# **TRANSIT EFFECTIVENESS PROJECT Responses to Comments**

**City and County of San Francisco Planning Department  
Case No. 2011.0558E**

DATE: March 13, 2014  
TO: Members of the Planning Commission and Interested Parties  
FROM: Sarah B. Jones, Environmental Review Officer  
Re: **Attached Responses to Comments on Draft Environmental Impact Report Case No. 2011.0558E Transit Effectiveness Project**

**RESPONSES TO COMMENTS  
TRANSIT EFFECTIVENESS PROJECT  
PLANNING DEPARTMENT CASE NO. 2011.0558E**

(Revised) FIGURE 23 - TTRP.30 EXPANDED ALTERNATIVE

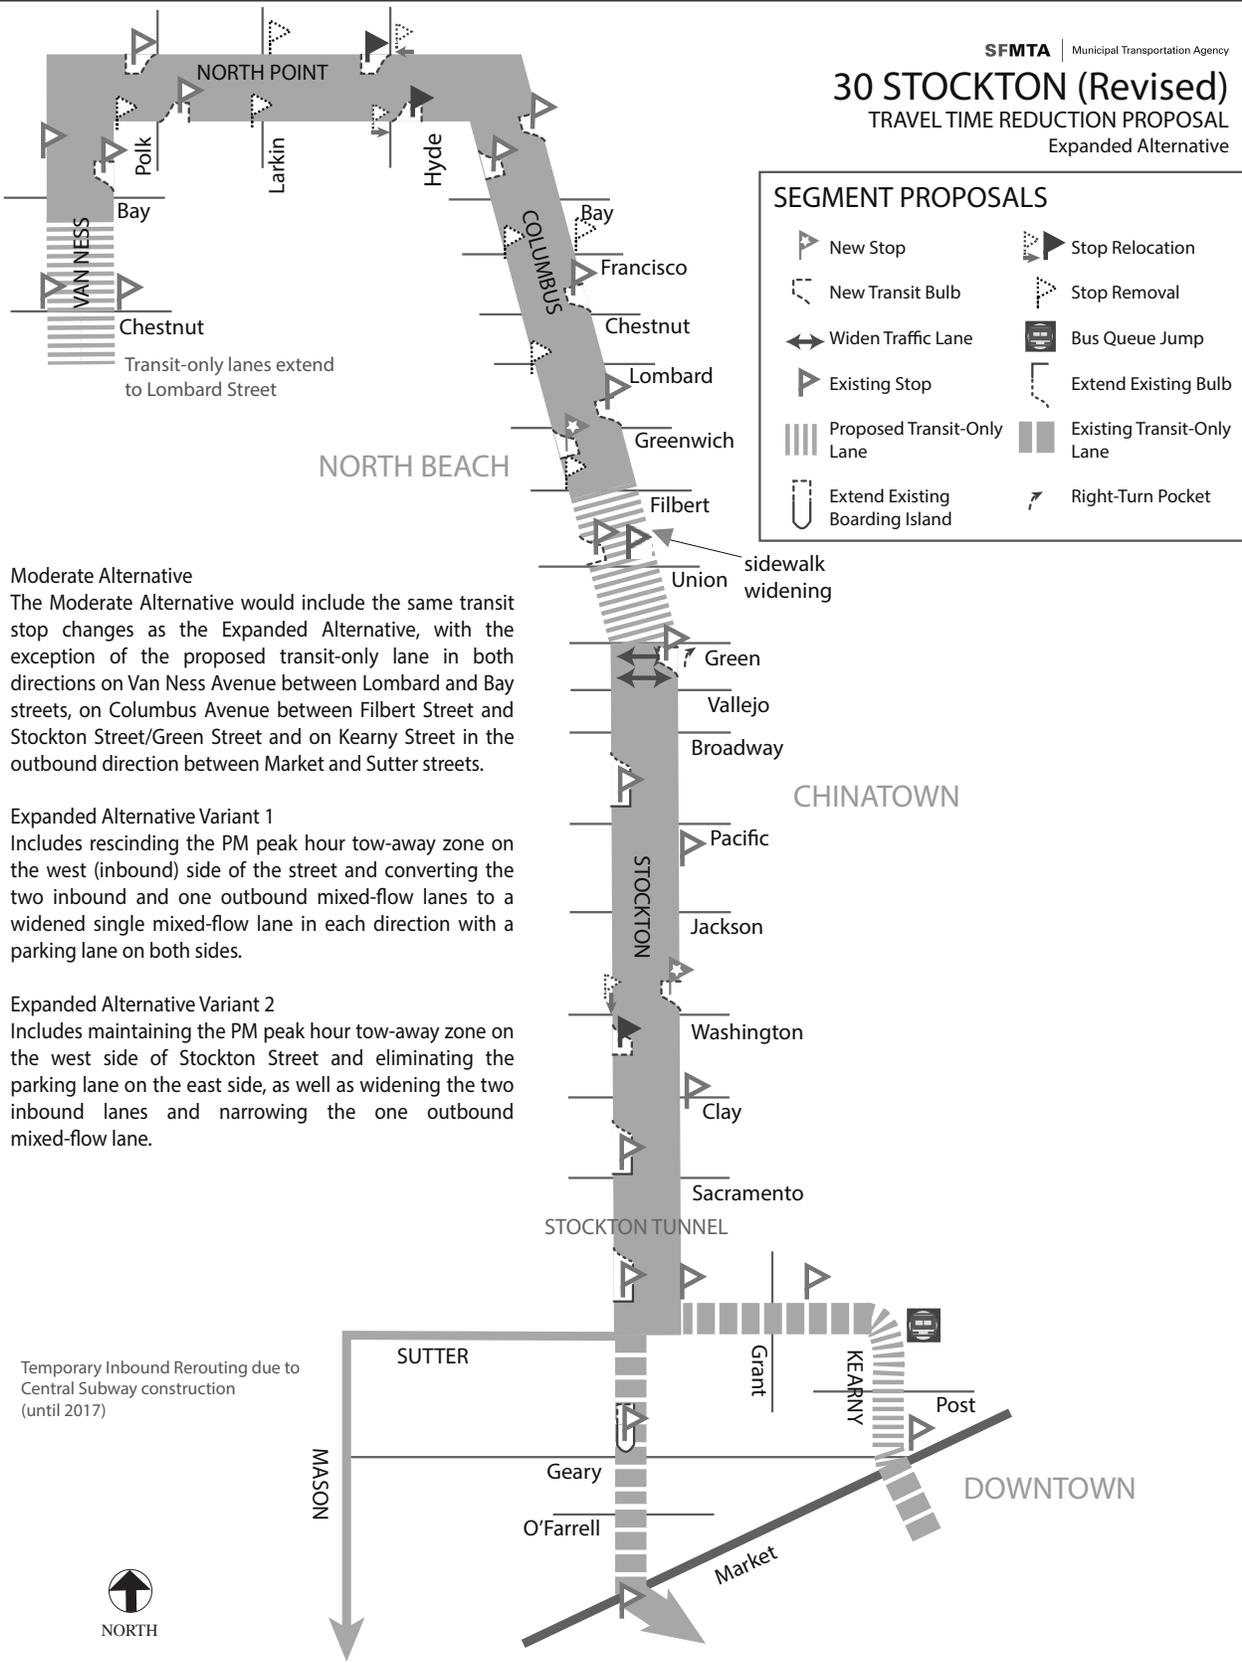
The Expanded Alternative would include all the transit stop changes included in the Moderate Alternative as well as the sidewalk widening along the east side of Columbus Avenue between Union and Powell streets.
- \* Figure 23: TTRP.30 Expanded Alternative on EIR p. 2-160 has been revised to show that under the Moderate and Expanded Alternatives sidewalk widening would occur on the east side of Columbus Avenue on the entire block between Union and Powell streets. Revised Figure 23 is shown on the following page.

(New) FIGURE 23a - TTRP:71\_1 EXPANDED ALTERNATIVE

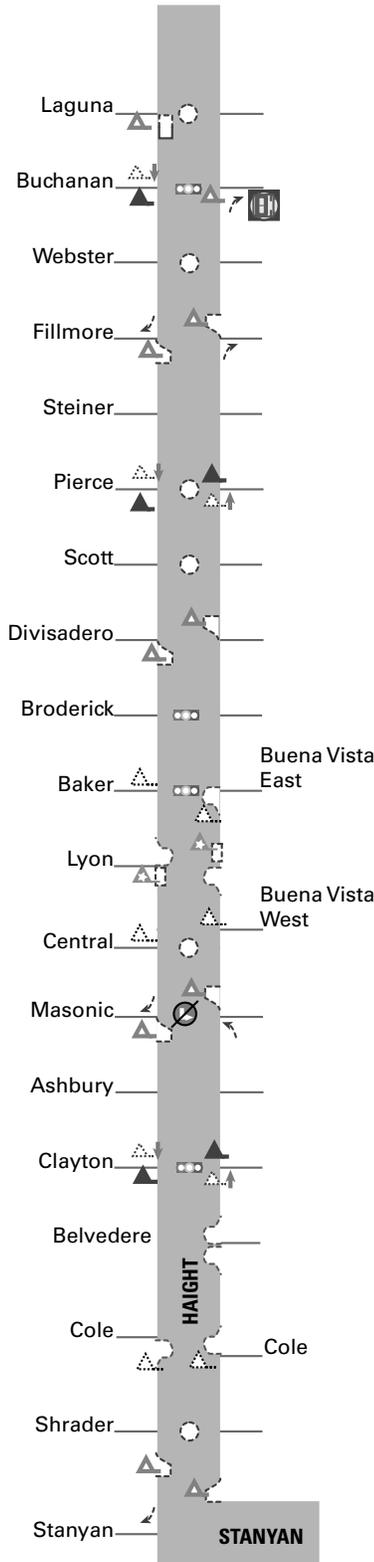
Figure 23a shows TTRP.71\_1 Expanded Alternative and describes the differences between the Moderate and Expanded Alternatives. Please see information and additional graphics illustrating the TTRP.71\_1 project at the SFMTA Web site, online at <http://www.sftepc.com>.

**Line 10 - Sansome**

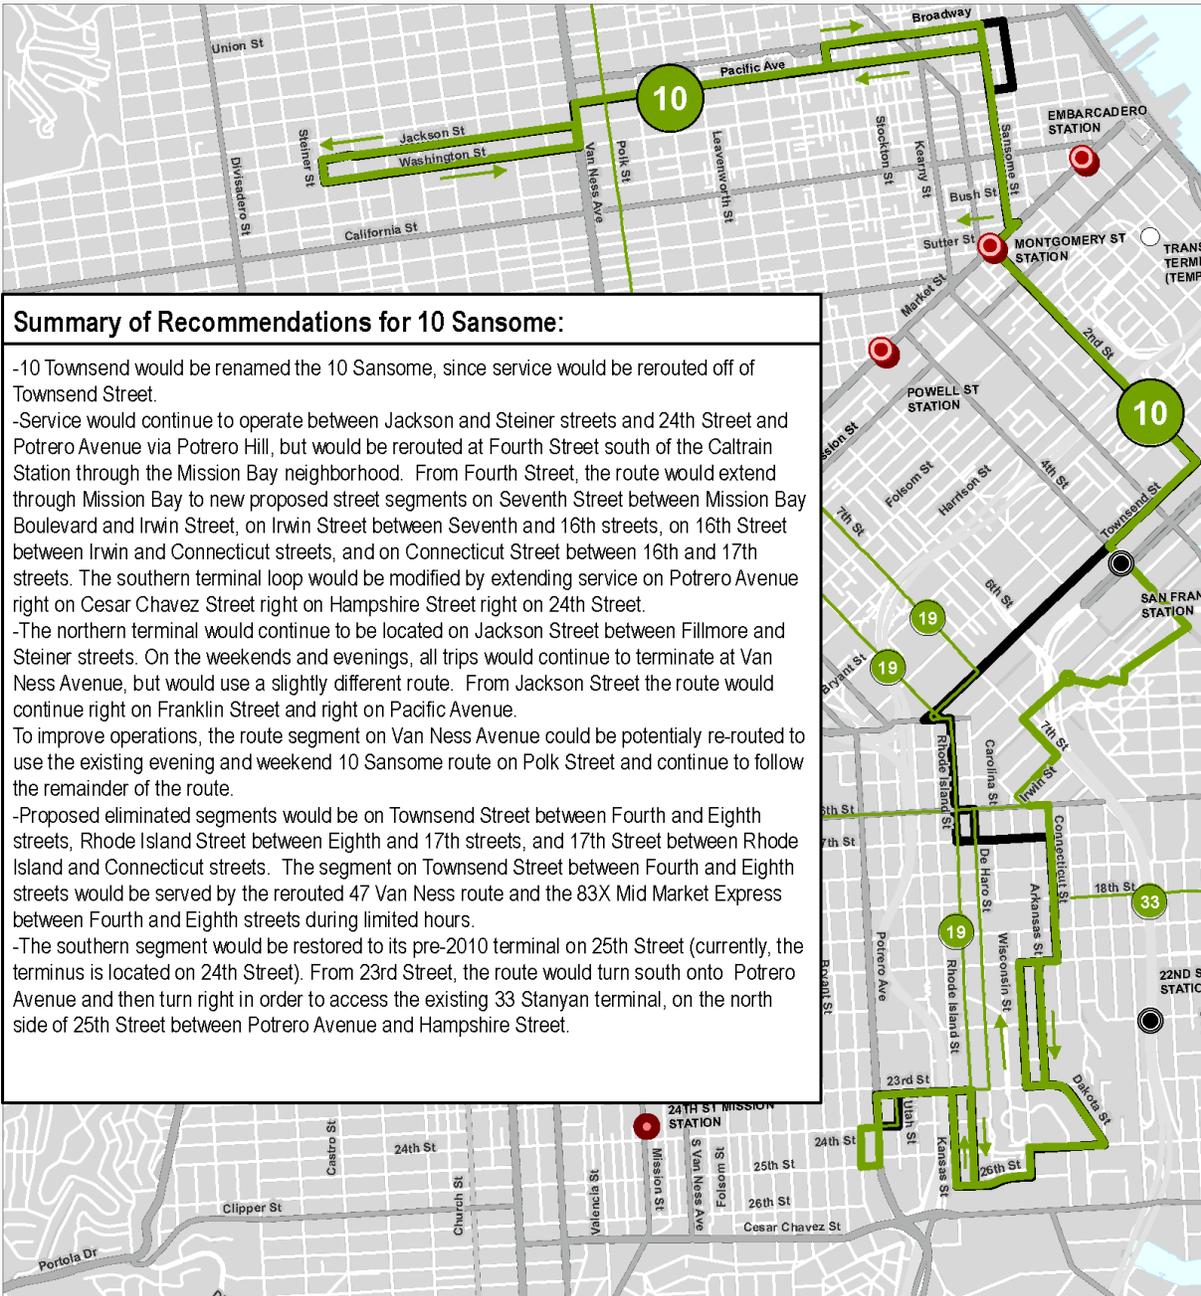
The Line 10 – Sansome Service Improvement Map provided in Initial Study Appendix A, Service Improvement Maps, has been revised to clarify the embedded text and graphic for the weekend and evening variation on the existing loop on the northern segment of the route in the vicinity of Van Ness Avenue.
